Job No. 17 6812

SUBJECT: RESPONSE TO CYCLE ISSUE COMMENTS-LDR GEOLOGY
Phnx/Chan + Chung Residence
4004 Arroyo Sorrento Rd.
San Diego, CA 92107
Assessor's Parcel Number 307-060-43-00
City of San Diego Project No. 0698398

This report has been prepared in response to the City of San Diego, *Cycle Issues*, dated January 13, 2022. This Memorandum is based on review of the project by the City's LDR-Geology reviewing discipline. This letter responds to Issue Numbers 3 through 9. Issue No. 1 is a list of references only. In order to provide continuity of discussion, we are responding to the memorandum's issues in the numerical order requested in the document.

**SITE GEOLOGIC MAP 1
FIGURE NO. 2A**

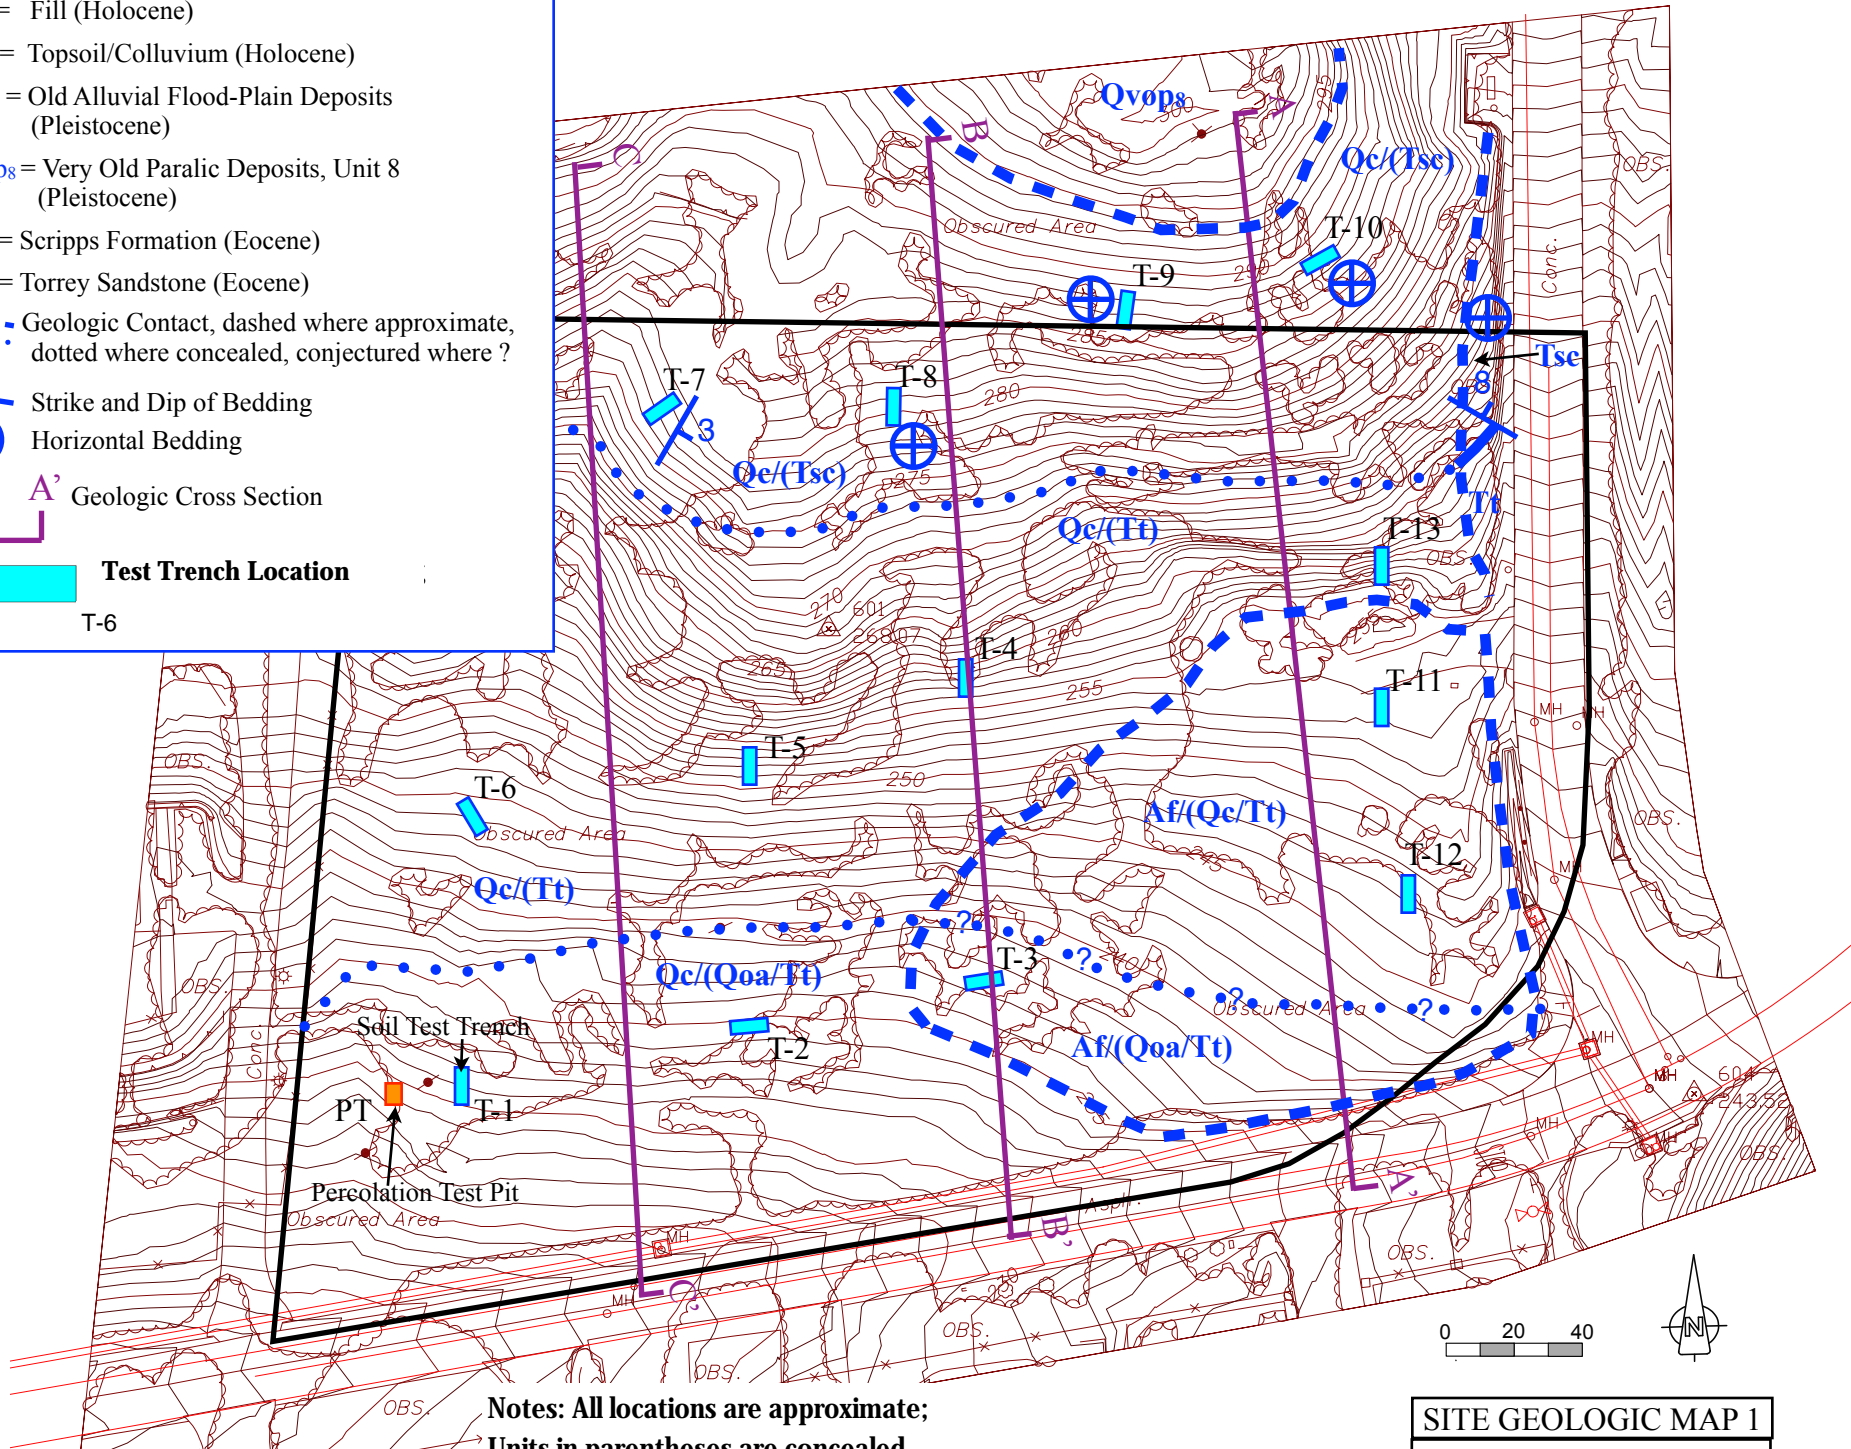
4. *The proposed development appears to have changed since the referenced report was prepared. Provide an updated Site Geologic Map, Figure No. 2B that shows the current proposed construction.*

The Site Geologic Map, Figure 2B, has been updated using the current grading plan as a base map and is attached to this report. Also for easier reference, a copy of the original geologic map (Figure 2A) is attached, which uses the existing topography as a base map. Additionally, the geologic cross sections from the 2017 report have been

**FIGURE NO. 2B
(Updated 3-16-22)**

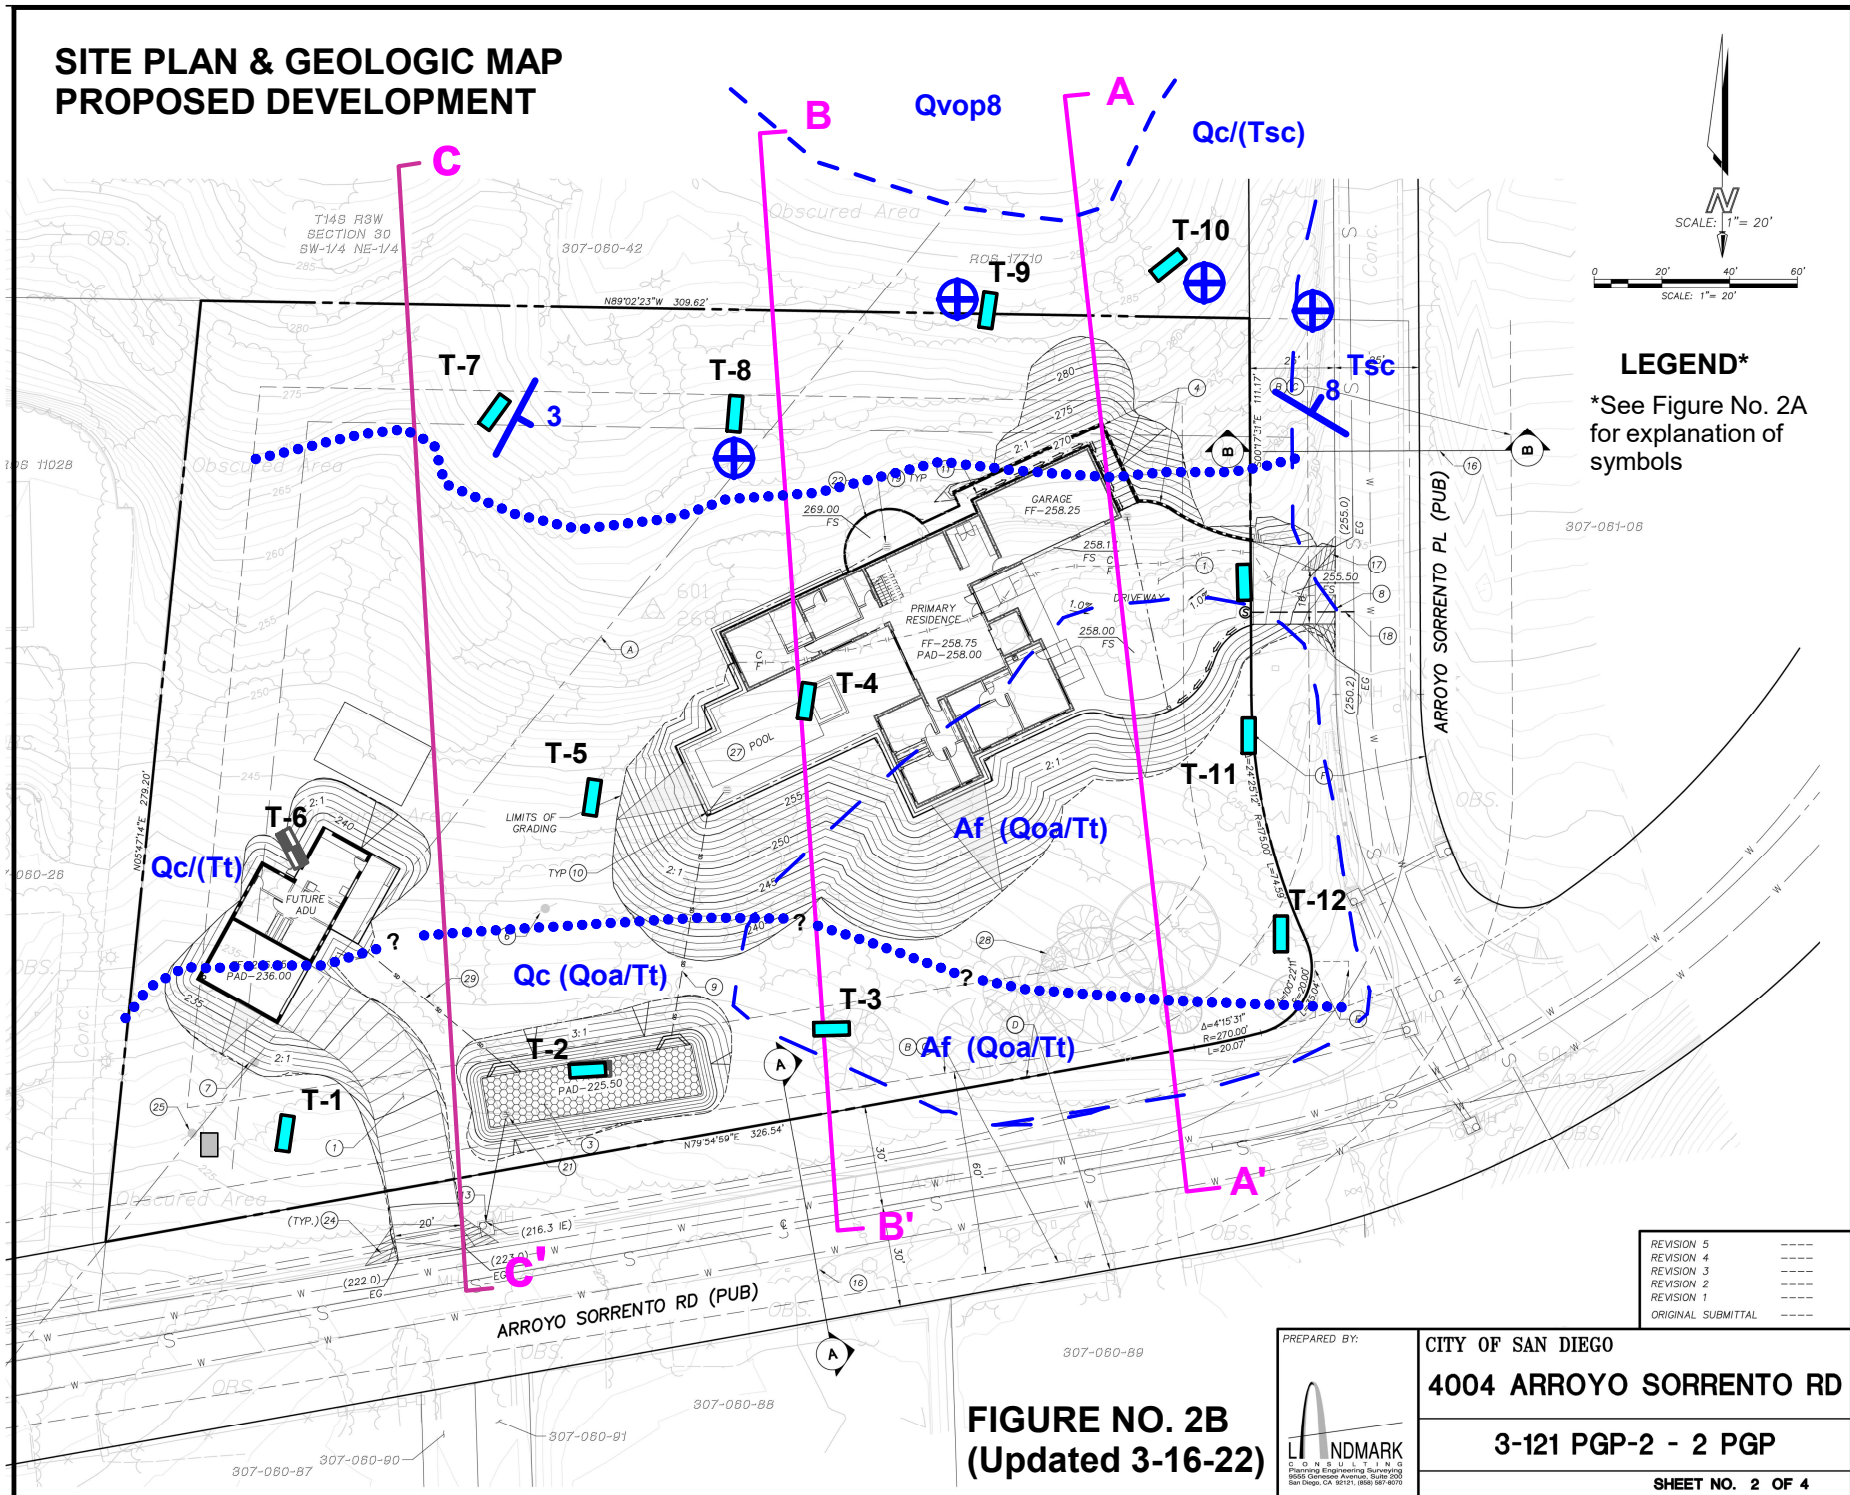
5. *Circumscribe the limits of anticipated remedial grading on the geologic/geotechnical map to delineate the proposed footprint of the project.*

As described previously, the current grading plan was used as a base map for the updated geotechnical map. The grading plan clearly indicates the area of the project that will be subject to grading. Grading will be limited to constructing the building pads, as indicated on the plan; the site will otherwise not be disturbed.
